In the Matter of)
) Docket 50-344
PORTLAND GENERAL ELECTRIC COMPANY,)
) (Control Building Proceeding)
et al)
)
(Trojan Nuclear Plant))

I hereby certify that on June 29, 1979, Licensee's letter to the Director of Nuclear Reactor Regulation dated June 29, 1979 and an attachment entitled "Request for Additional Information, Trojan Nuclear Plant, Proposed Control Building Design", have been served upon the persons listed below by depositing copies thereof in the United States mail with proper postage affixed for first class mail.

Trojan Nuclear Plant
Docket 50-344
License NPF-1

Enclosed are responses prepared by Bechtel Power Corporation to an additional 14 of the 50 questions submitted in your letter of May 18, 1979. In accordance with our discussion with your staff, we expect to transmit responses to the remaining questions by July 6.

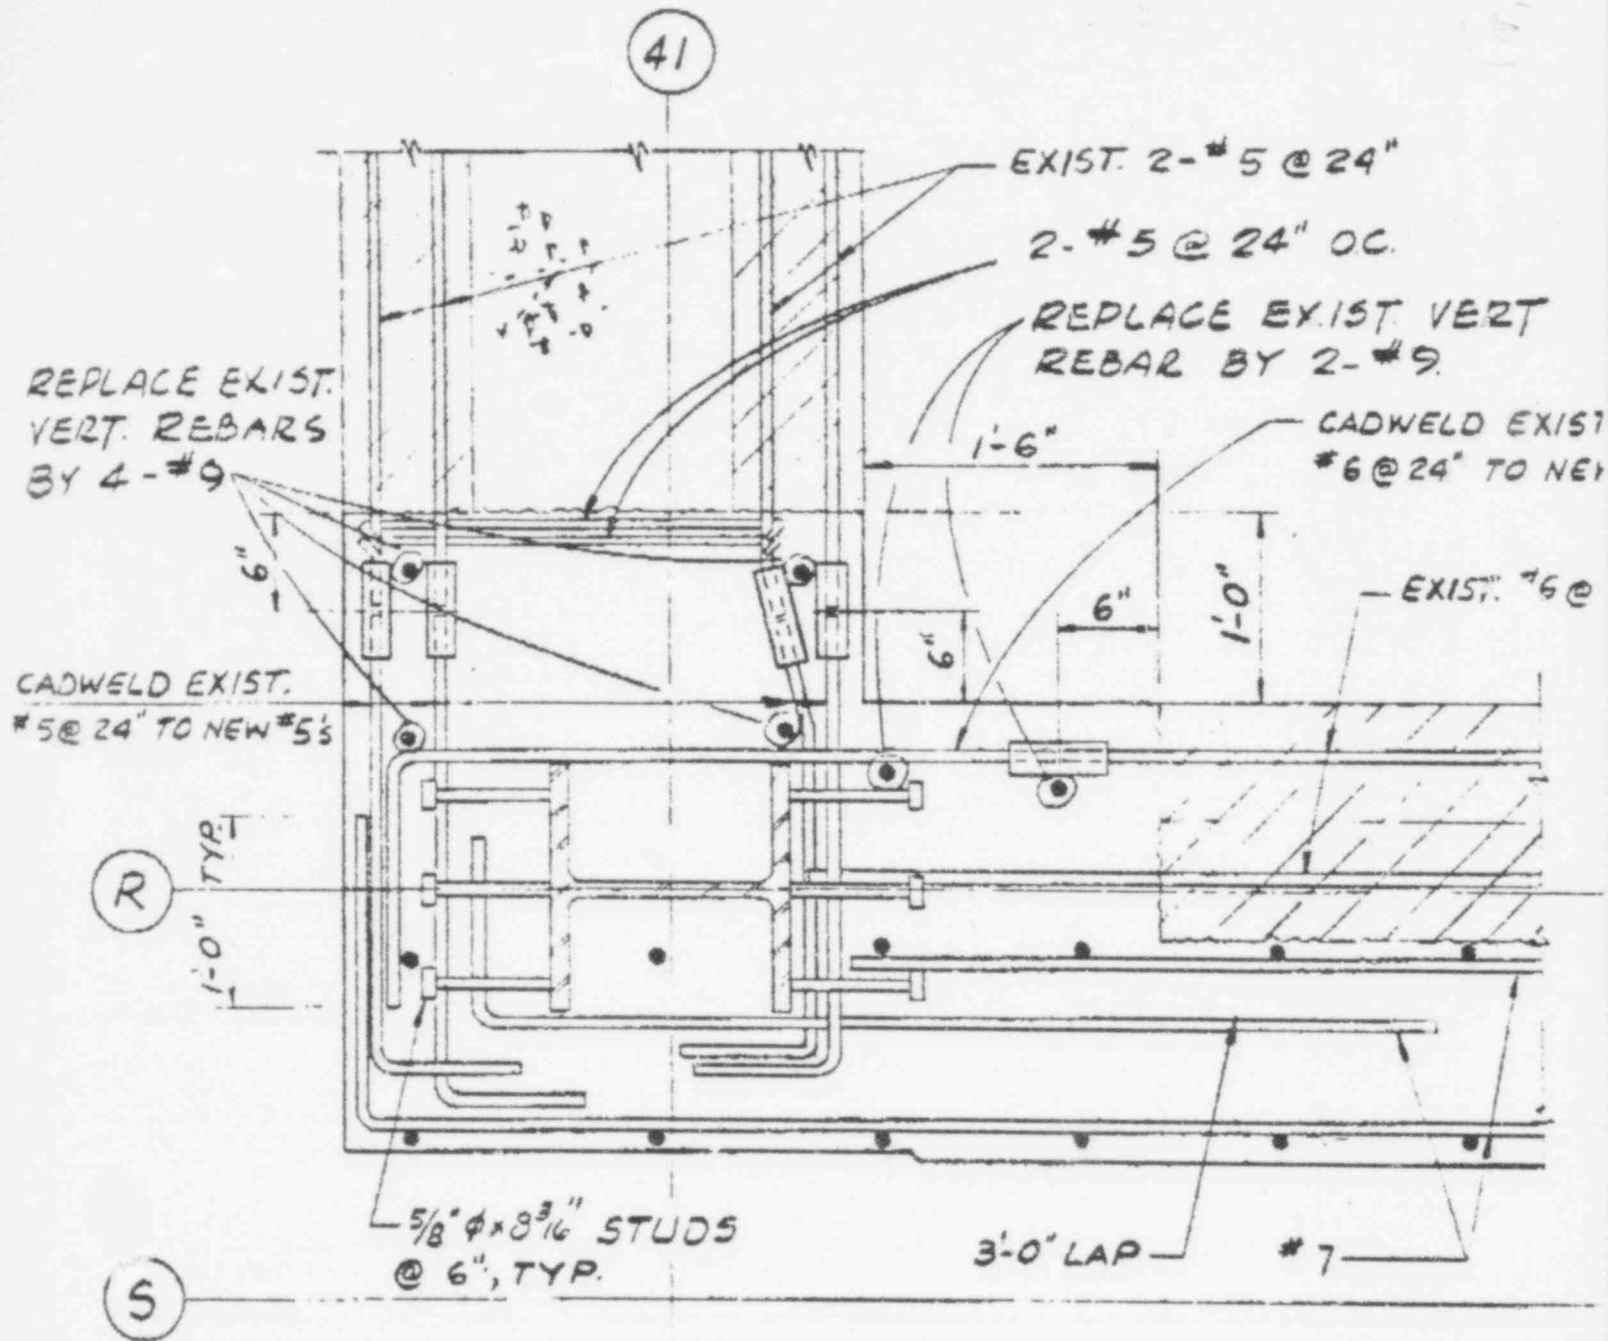
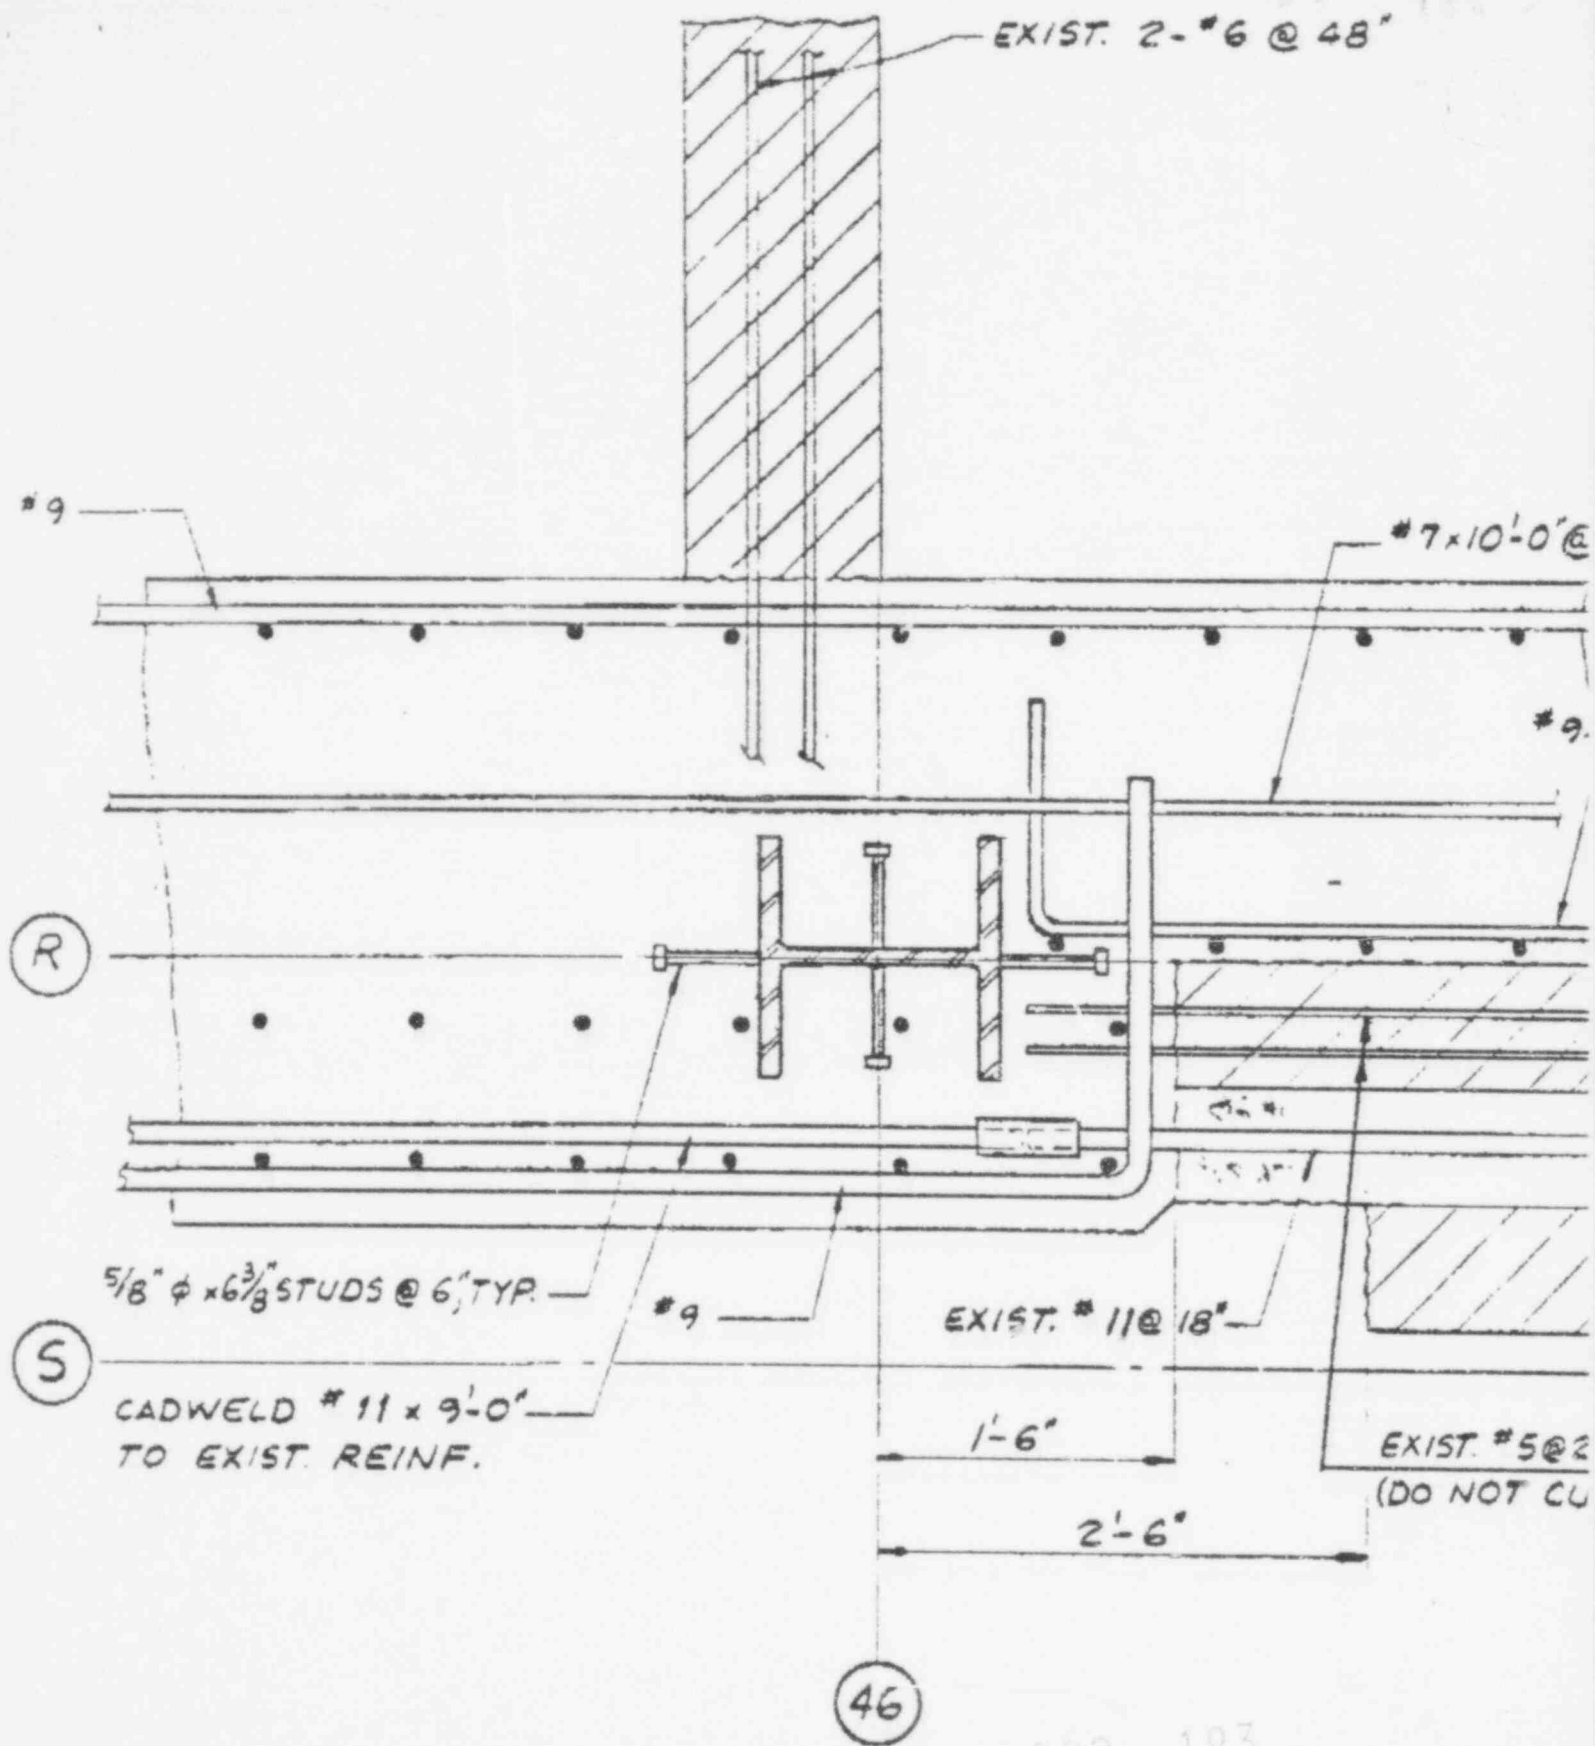
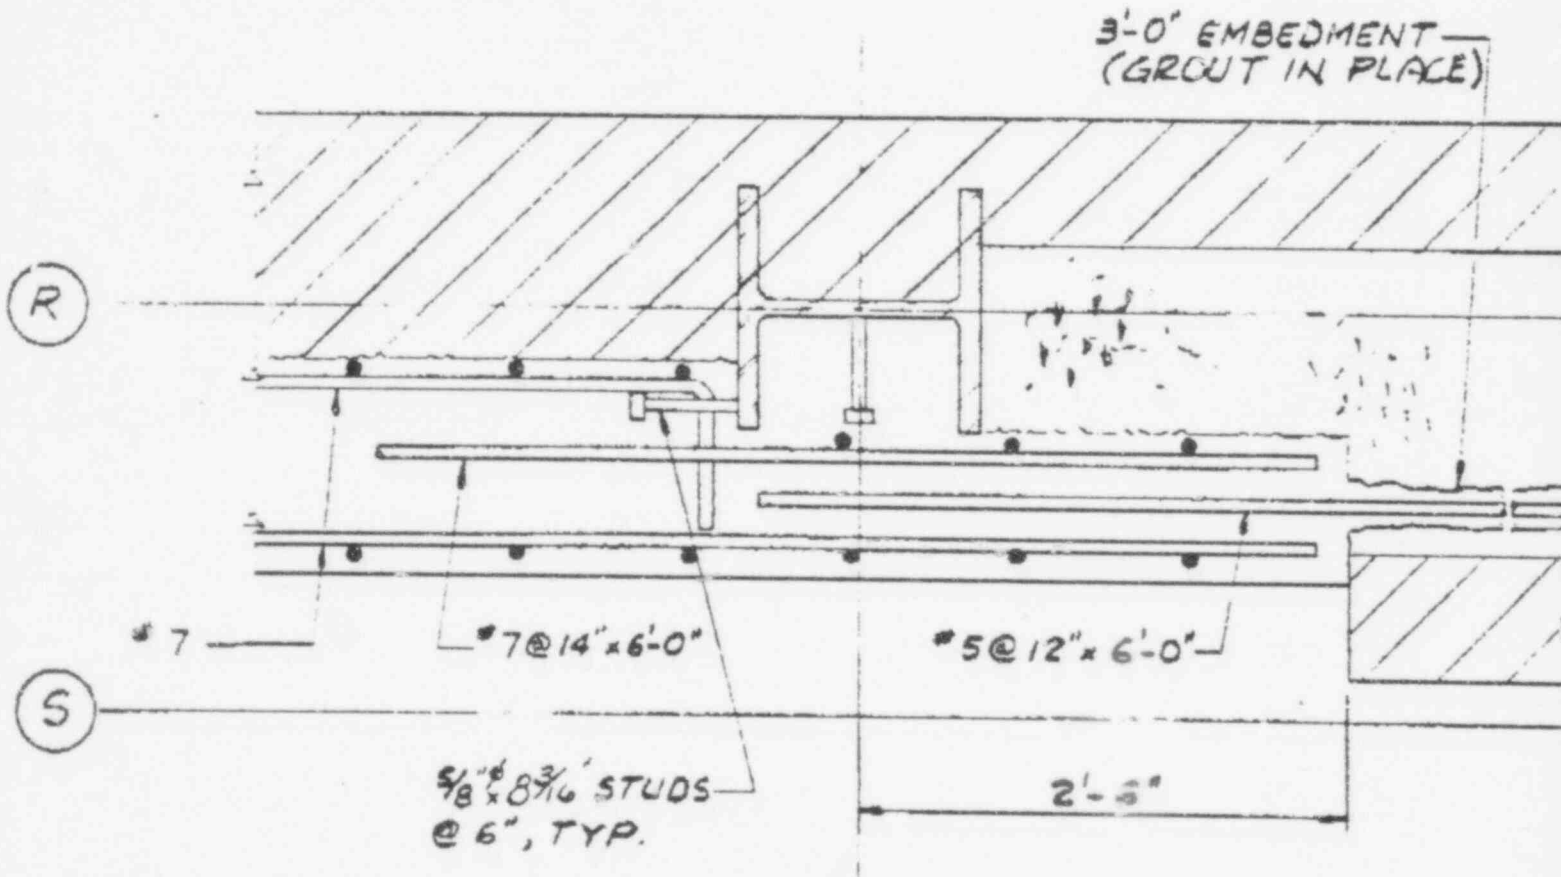
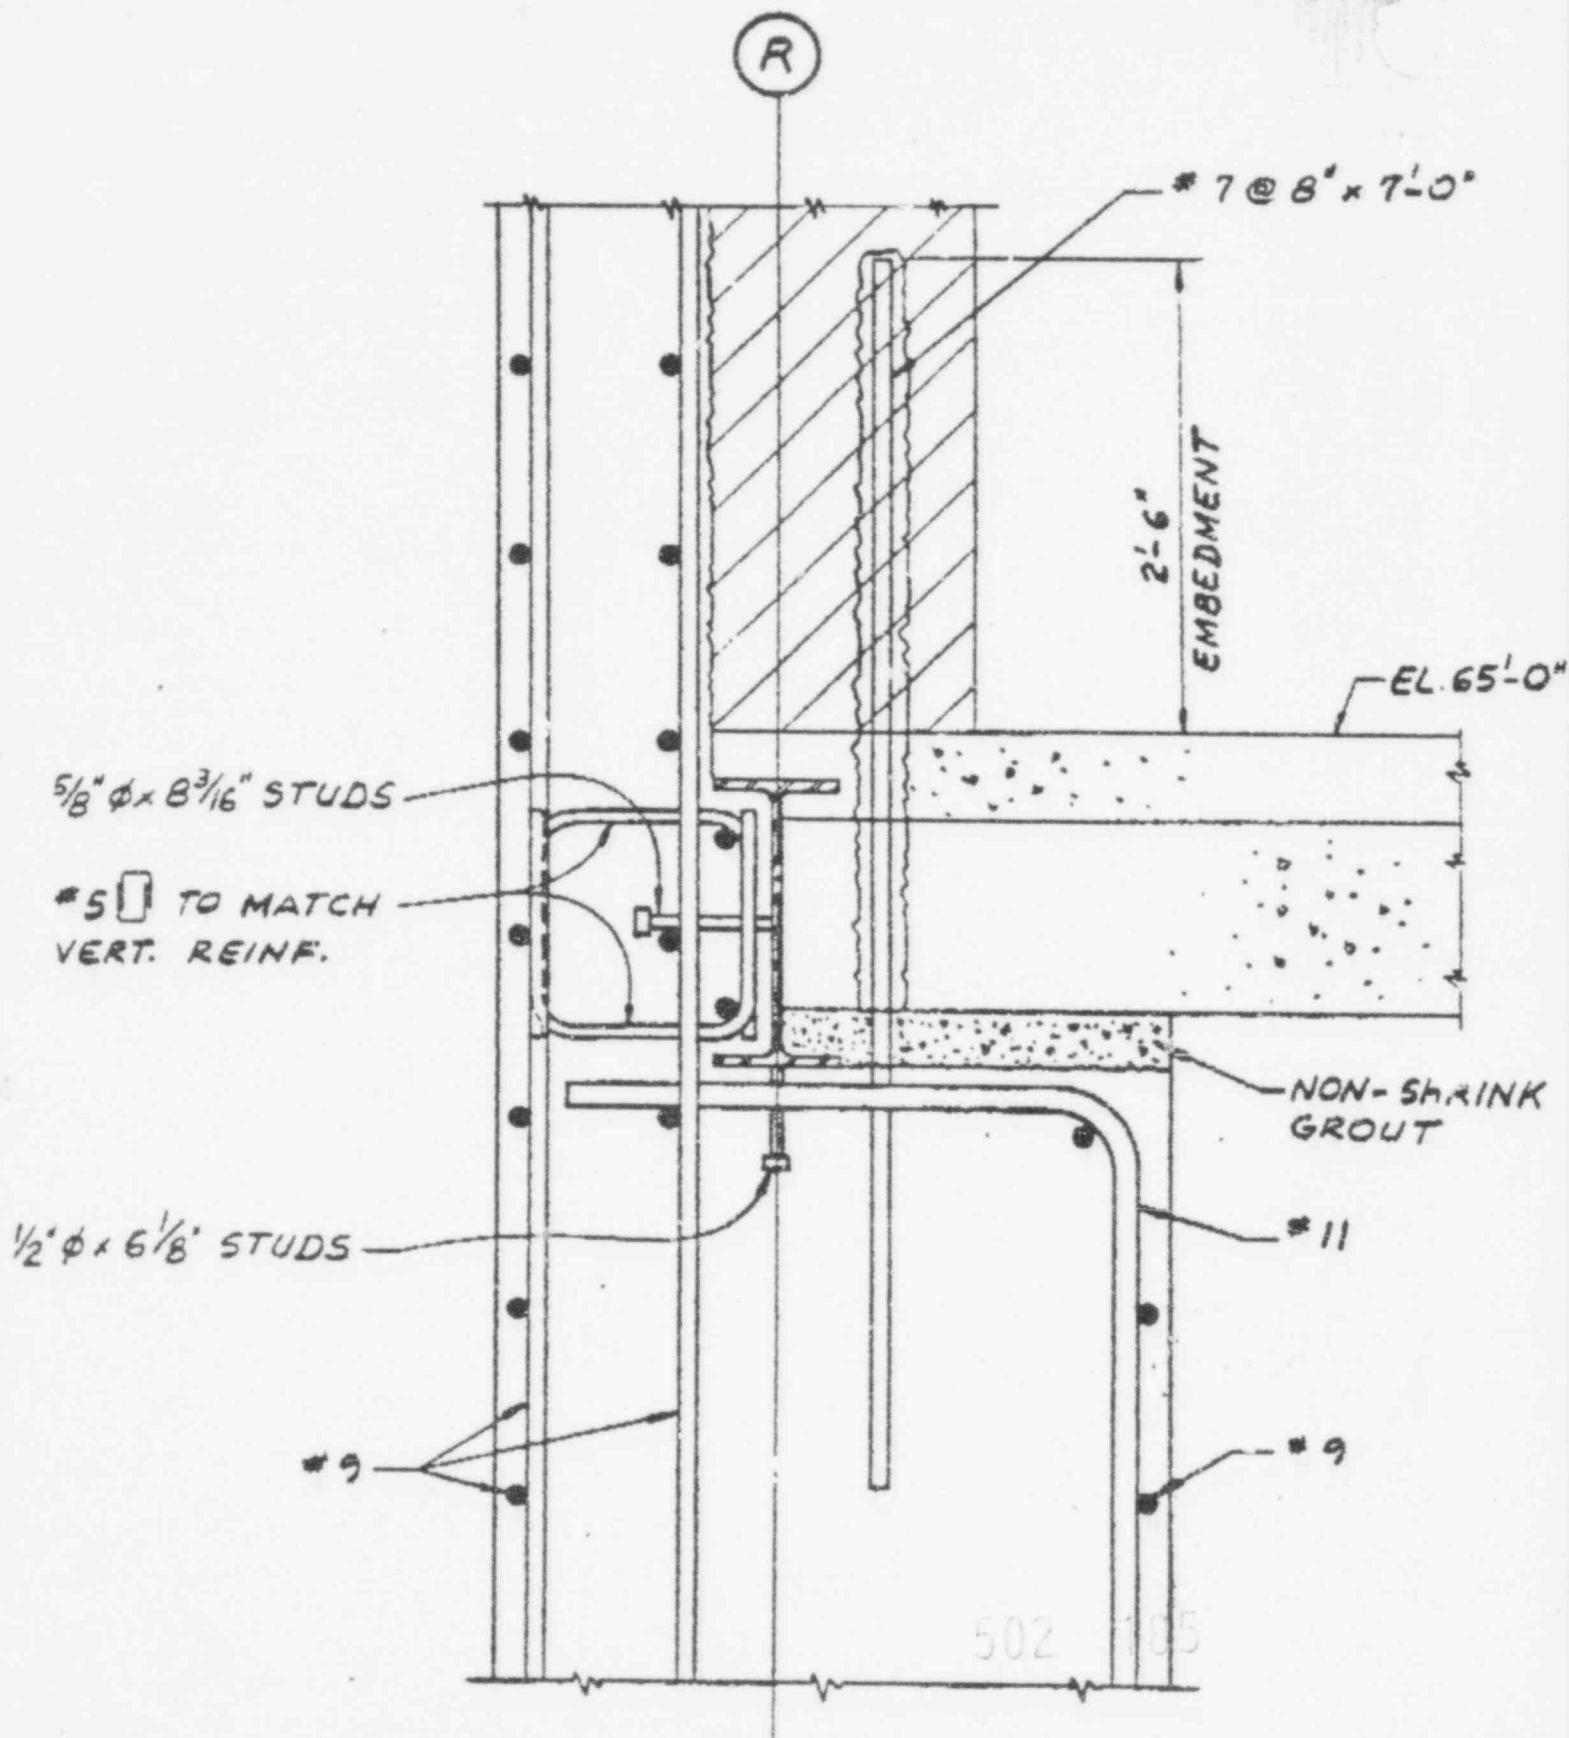
Provide clear, detailed sketches and descriptions of the connection interfaces of the additional walls to the existing structure. Additionally, describe the methods by which the effects of concrete creep and shrinkage (causing tension in the walls and/or a reduction in assumed dead weight) have been factored into the design of these additional walls. Describe and justify in detail the design and the procedures for the connections of the new walls to the existing structure.

Detailed sketches of the connection interfaces between the new walls and the existing structure are attached. The final design may require some minor revisions to the actual sizes and spacings of the rebar and studs. The sketches show representative connection details that will be used. The connection interfaces are discussed below.

Typically, where steel beams occur at a horizontal interface, studs are used to transfer shear forces and vertical rebars are used to transfer tension forces. At horizontal interfaces where steel beams do not exist, vertical rebars make the connection. In some cases friction type A-490 bolts are also used in the connections between the new walls and the existing concrete.

The typical treatment for vertical interfaces is to expose the columns and weld studs to them. New rebars are spliced with the exposed horizontal existing rebars by cadwelding. Drilled and grouted horizontal rebars are also used to make the connections.
